St. Lucie Unit 1
Docket No. 50-335
Proposed Exigent License Amendment
Thermal Margin and RCS Flow Limits

ATTACHMENT 4

ST. LUCIE UNIT 1 MARKED-UP TECHNICAL SPECIFICATION PAGES

FIGURE 2.1-1 REACTOR CORE THERMAL MARGIN SAFETY LIMIT - FOUR REACTOR COOLING PUMPS OPERATING

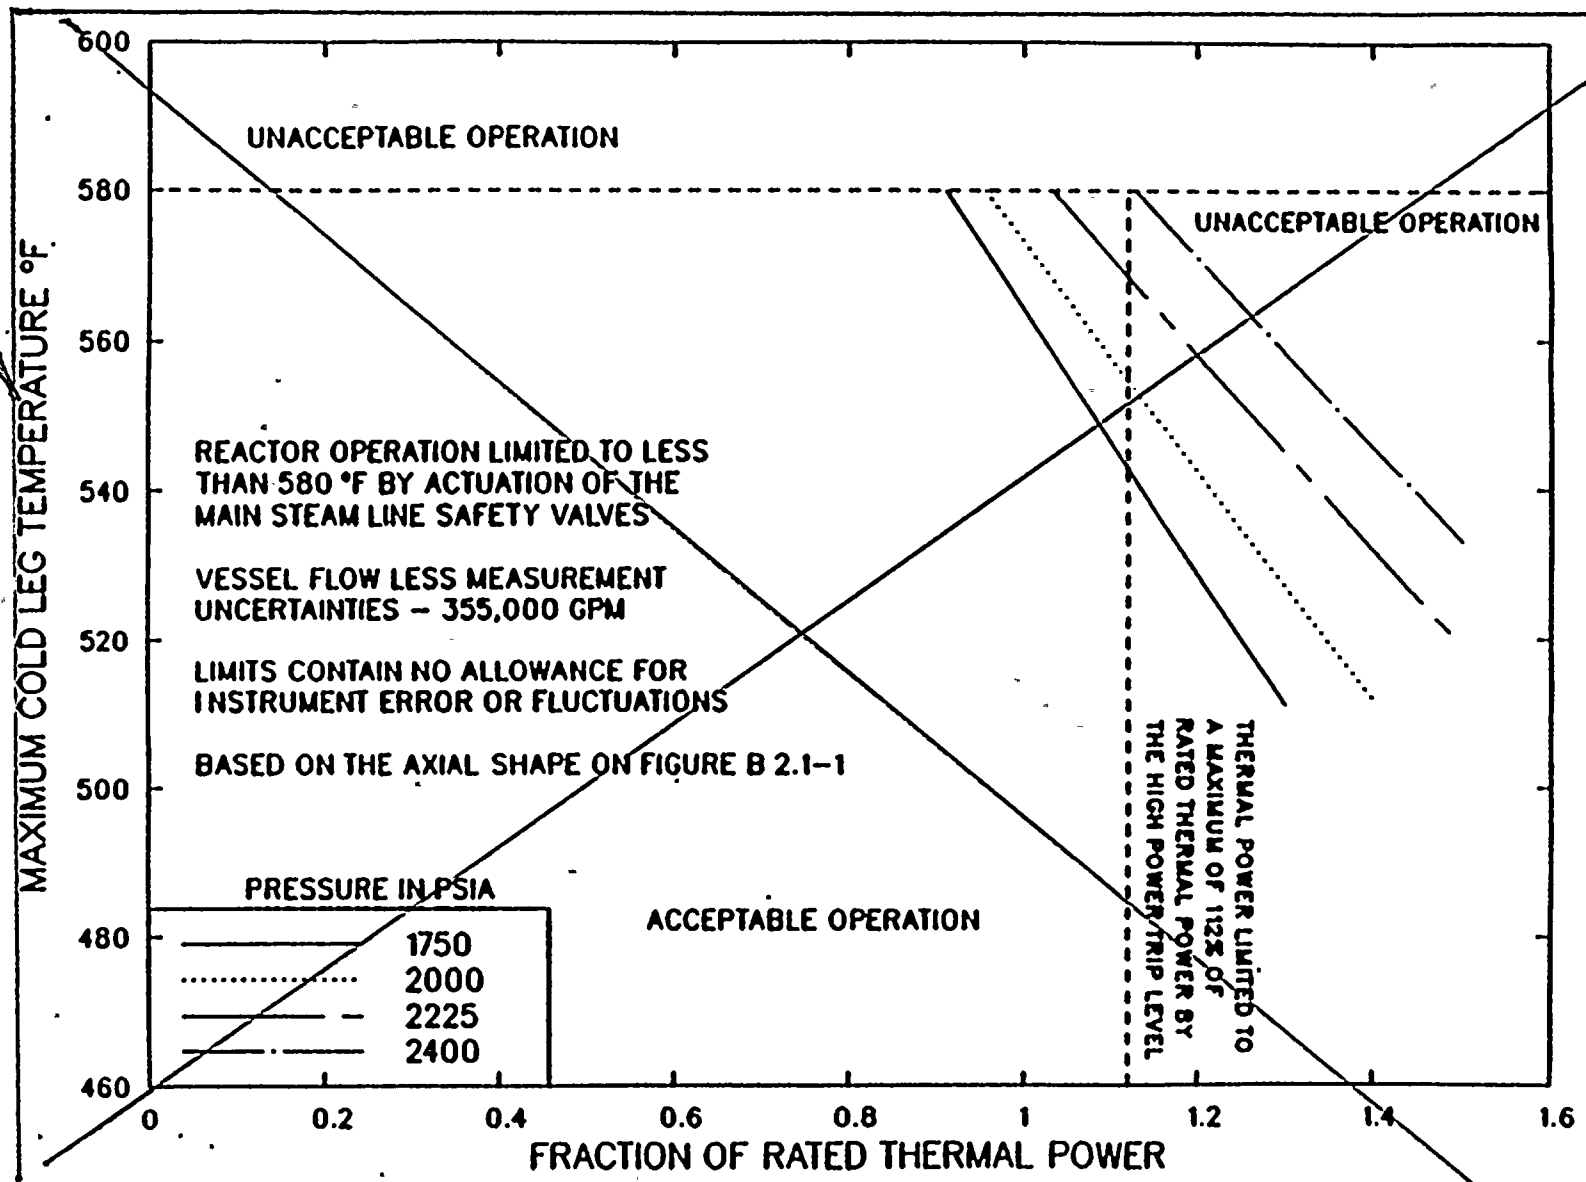
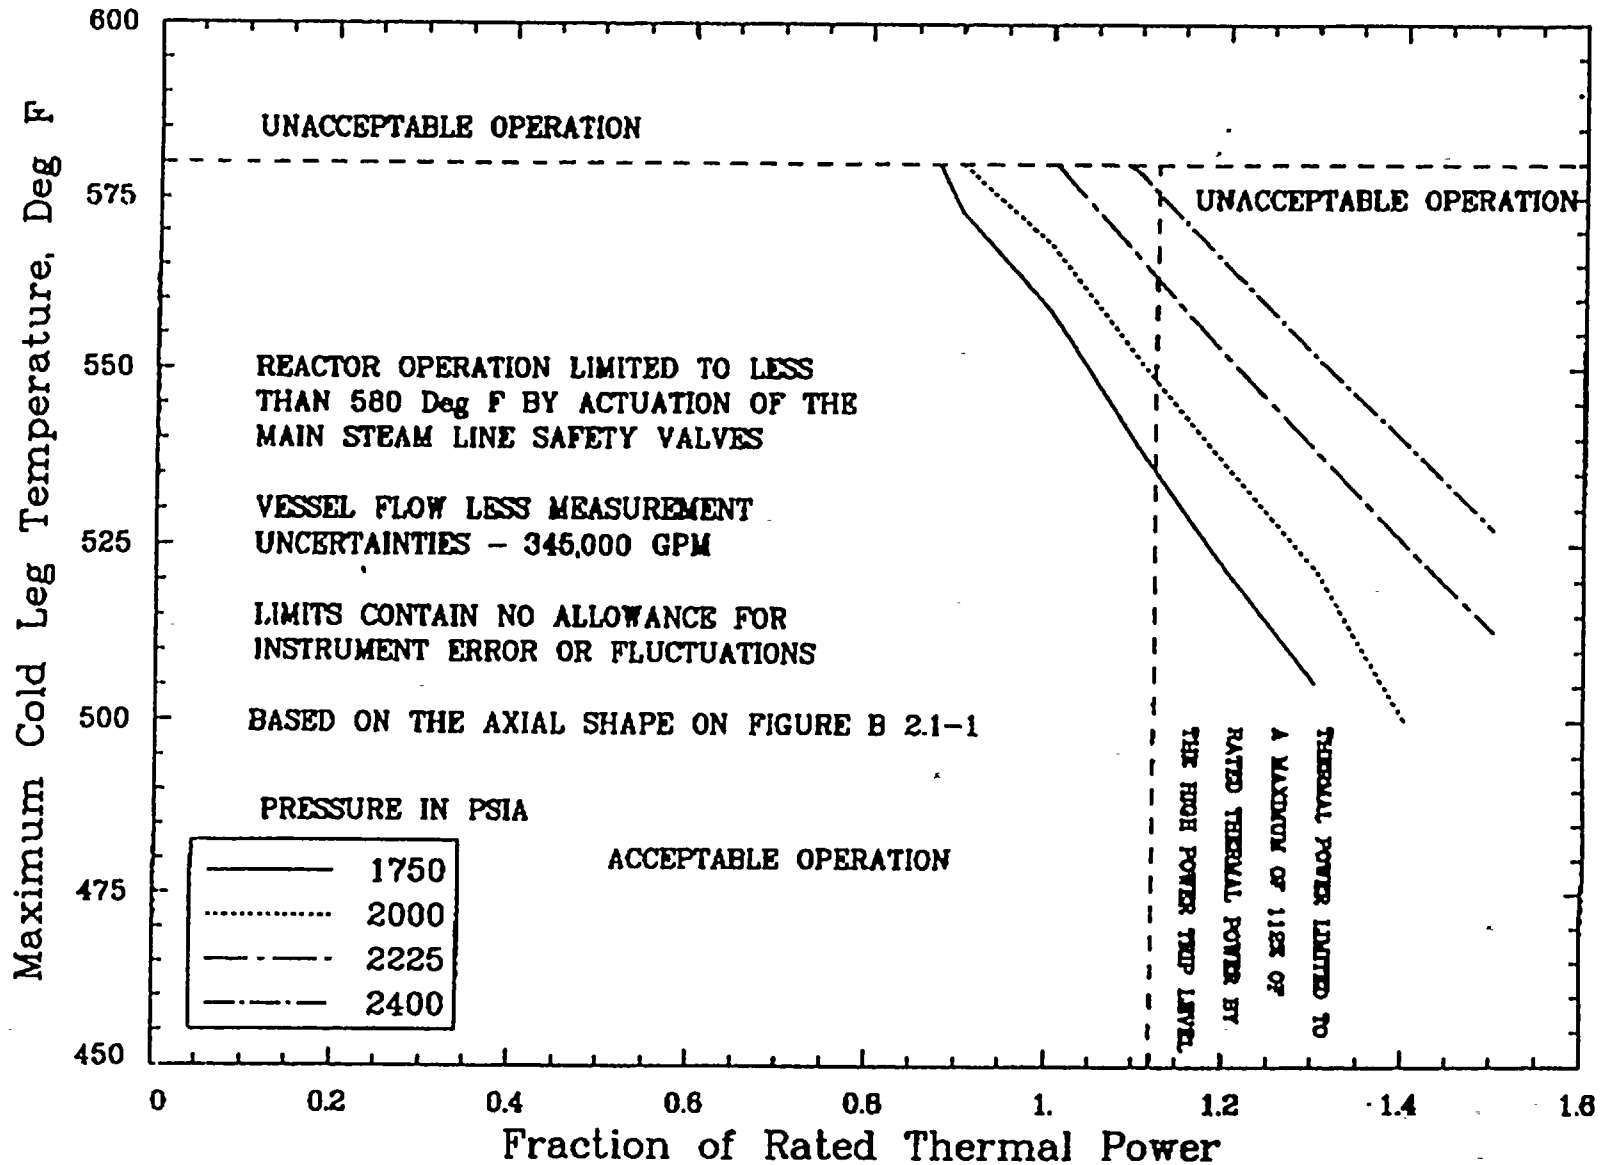
REPLACE WITH REVISED FIG. 2.1-1 (NEXT PAGE)

FIG. 2-1-1 (NEXT PAGE)
WITH REVISED
& REVISION

Revised Figure 2.1-1
